MIRADA
COMMUNITY DEVELOPMENT DISTRICT

Advanced Meeting Package

**Mirada Community
Development District
Sign Analysis
Mirada Blvd. and Setter Palm**

SUMMARY OF SIGN INVENTORY

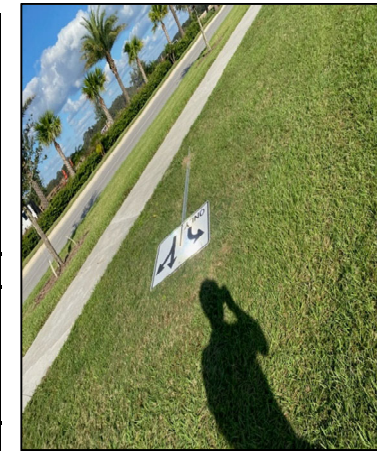
A total of 2 signs did not meet the minimum height requirement (sign number 2 and 8) and 1 did not meet the roadway offset requirement (sign 6).

NOTES: Sign is missing street names
and sign offset is required to be 1'-6" from back of curb

NOTES: Sign to be installed 1'-6" offset from Back of Curb and 7'-0" minimum from the ground to the bottom of the sign
